## **s92 - Request for Further Information and Affected Party Approval**

I have reviewed your resource consent application **RC234003** to establish a storage business at 14A Leeston and Lake Road, Leeston. More information is needed so that I can better understand your proposal and its potential effects.

**RE: LAND USE CONSENT APPLICATION UNDER RMA 1991 – RC234003 – 14A LEESTON AND LAKE ROAD, LEESTON**

**ELEVATIONS**  
Storage Building Leeston

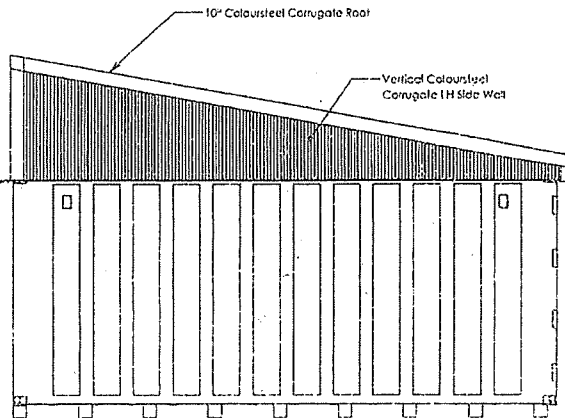
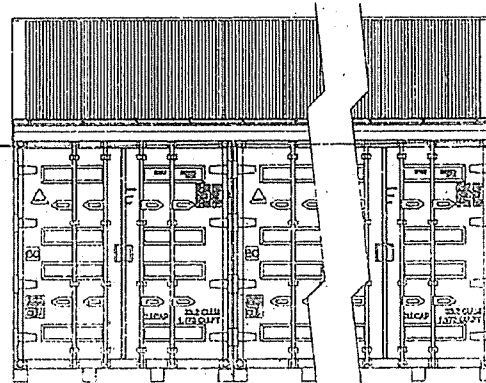
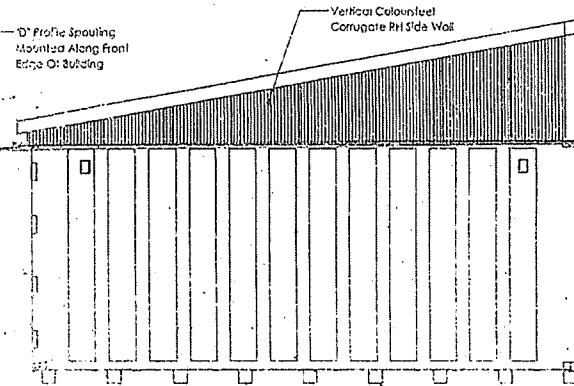
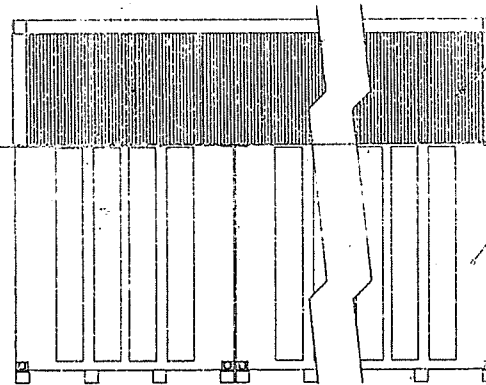
2. Please provide scaled elevations of the proposed storage structure<sup>1</sup>. This is to confirm compliance with the building standards of both the Operative and Partially Operative District Plans. Stating the structure's dimensions is not adequate.

1. Please find attached an updated Record of Title for the site.
2. Please find attached an updated site plan prepared by the applicant at a 1:50 scale. Regarding the elevations, you requested the application provided the shipping container elevations which were the 20ft container of essentially 6.09m x 2.4m wide by 2.59m high. The foundation design was prepared by CS Eng.NZ for the containers.
3. Environment Canterbury's Listed Land Use Register does not list this site as having had or currently having any HAIL activities occurring upon the land. Please see the attached report.
4. With regards to the split zoning, this creates the issue of that part of the access leg at 3.76m wide for circa 42m. This residential zoned area is the access/egress only for the site for vehicles. This needs to be applied for and details are below in terms of that assessment.

Indicative site plan only. The finished floor level must comply with the attached Flood Assessment Certificate

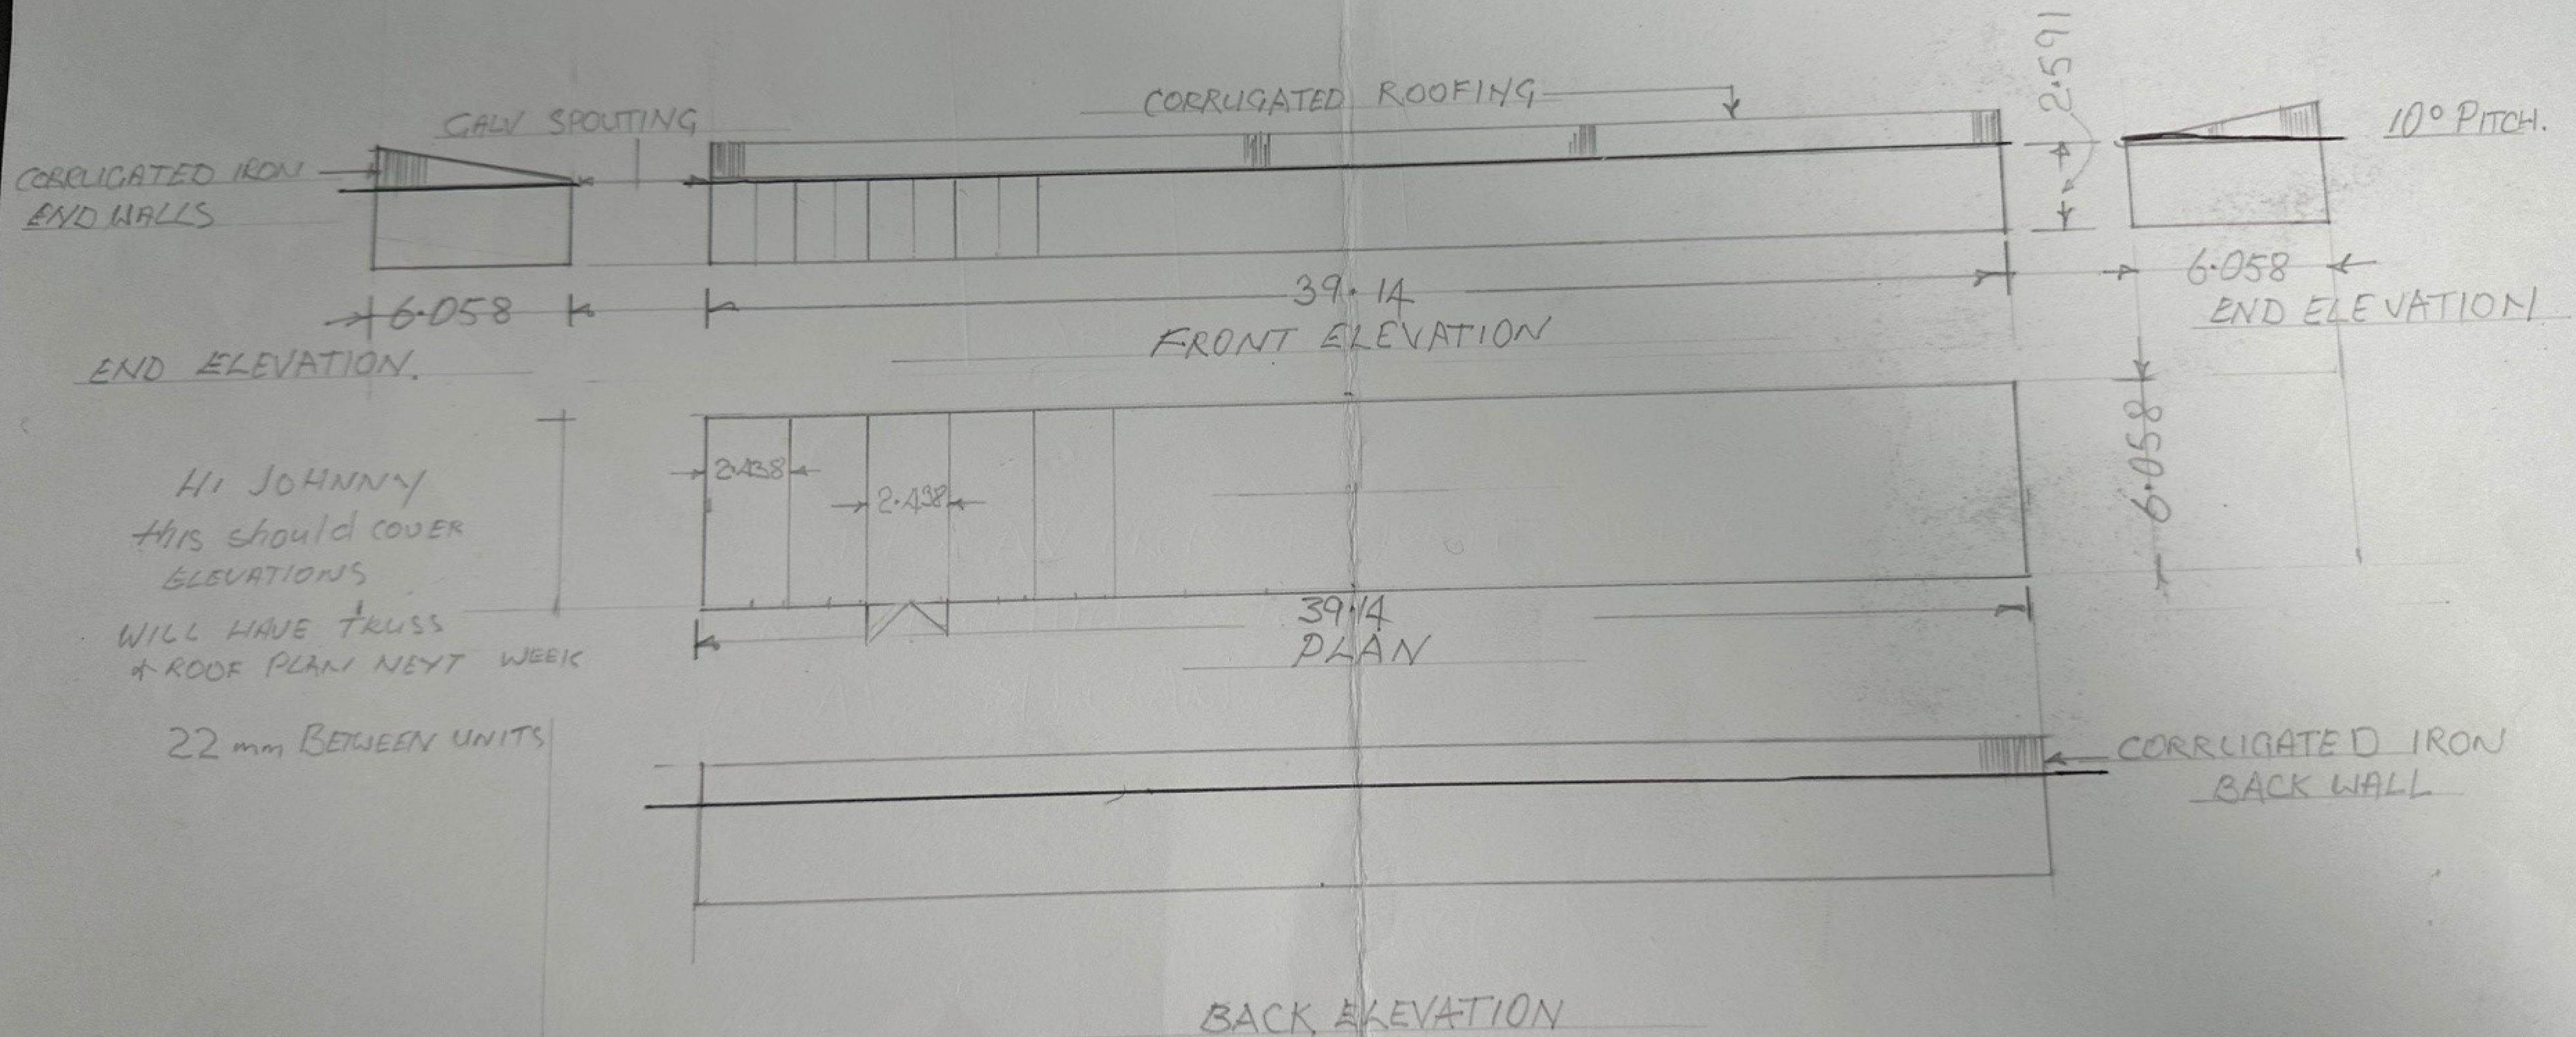
8. Please provided a scaled site plan that demonstrates compliance with GIZ-REQ6 landscaping – internal boundaries from the Partially Operative District Plan:  
*"Prior to erection of any principal building, where a site adjoins a residential zoned site, a minimum 2m wide landscape strip shall be established and maintained along the boundary. The landscaping shall be either a solid hedging of a species capable of achieving a height of at least 2m at maturity, or one tree per 10m of boundary ...  
...All planting and landscaping required by GIZ-REQ6.1., GIZ-REQ6.2., GIZ-REQ6.4., and GIZ-REQ6.5. shall be maintained, and any dead, diseased, or damaged plants shall be removed and replaced."*

9. Please confirm what, if any, outdoor storage is proposed. This must include any rubbish storage or utility areas. This must be clearly shown on the scaled site plan and an assessment against GIZ-REQ7 of the Partially Operative District Plan must be provided.

8. Please see the updated site plan where that part of the site adjoining the residential zone or properties has a 2m min width landscaping strip shown. The applicant will provide either plants that would form a hedge of 2m min height at maturity or 1 tree per 10 metres of space between. Part 9 of that rule requiring *Jun-24 all dead or diseased or damaged plants being removed and replaced*, will be met.

9. There is no outdoor storage of materials or rubbish or the like on this site. As mentioned, what may be stored, is a vehicle or vehicles such as a caravan, motorhome or boat, which are common for these types of facilities, uncovered on the grassed area of the site on a temporary basis. There is no outdoor storage that would create an issue for adjoining residential neighbours.
